This page lists the know errors on the gm5x5x5 PCBs. There are no known issues with the bulk order run (white pcbs), the following information is valid **only** for the prototype run (green pcbs).

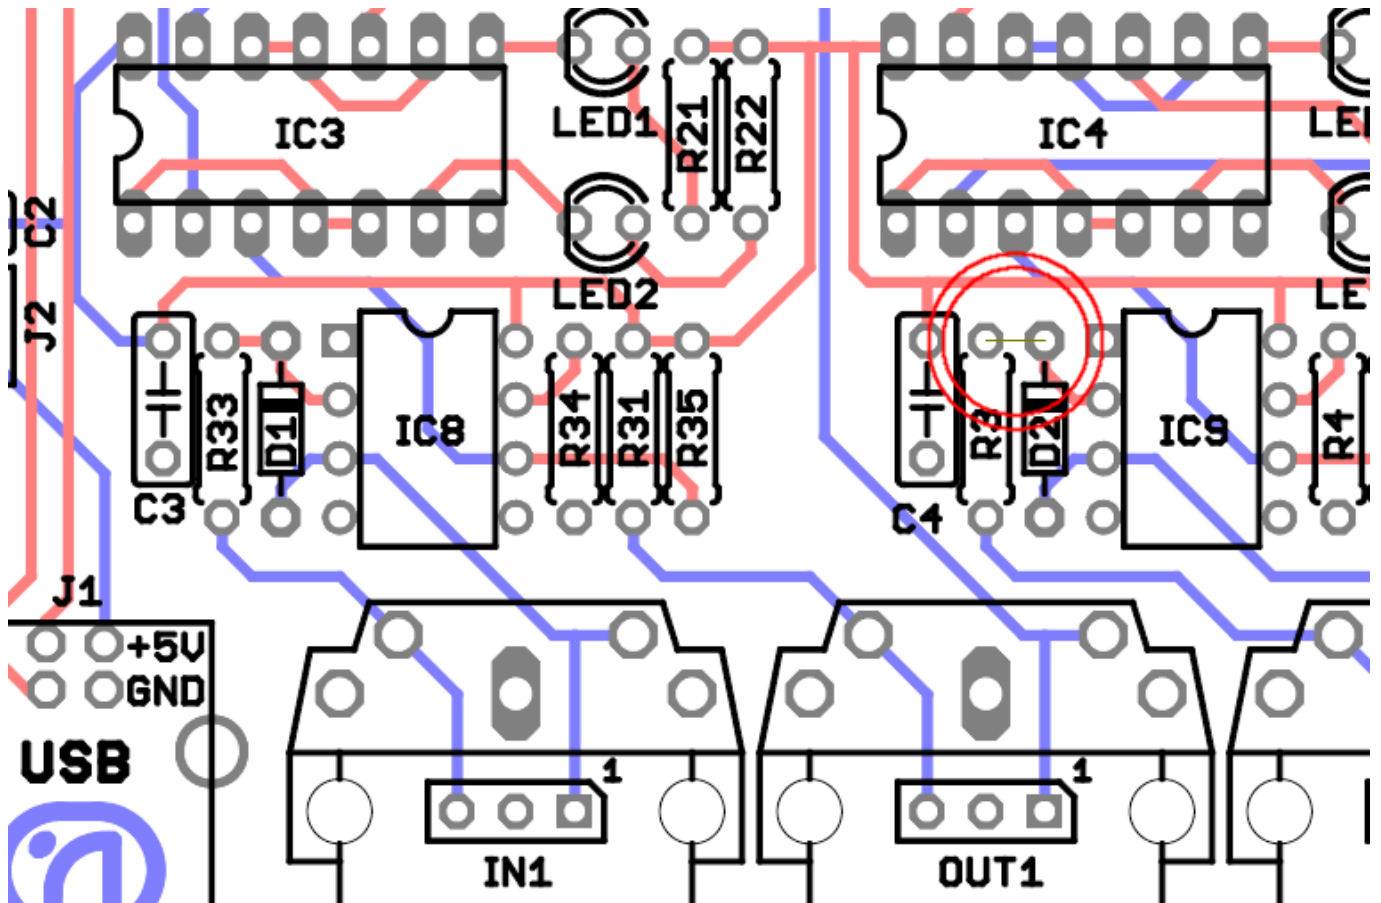
#1 Silkscreen error (reported by dioioib)

Problem: The silkscreen has the EEPROM the wrong way around - Pin 1 should be facing IC5.

Solution: Stick the EEPROM in the other way around, with the “notch” facing IC5.
